MANDATORY BULLETIN Z 142C/6a

1. **AFFECTED AIRCRAFT :** All Z 142C aircraft which should be approved for IFR flights.
2. **SUBJECT :** Provision of the airplane with the Alternate Static Source L 242.8259, which conforms with the applicable requirements of FAR 23.1325.

APPENDIX No. 1

Fig. 1

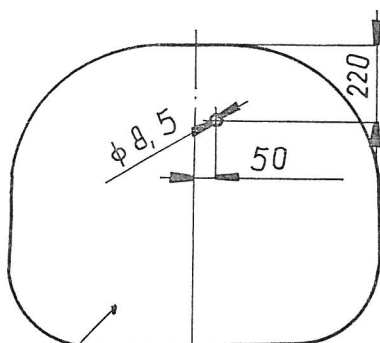
1. Drill the hole $\varnothing 8,5$ in the firewall according to the Fig.1.
2. Drill 3 holes in the L.H. side panel (above the Alternate Source switch) according to the Fig.2.

3. Install the probe assembly (1-4) into the hole $\varnothing 8,5$ on the firewall according to the Fig.3. Bend the probe cover (2) into required shape by bending over the Cylindric body $\varnothing 10$. Lock the nut (4) with a drop of the varnish (18).
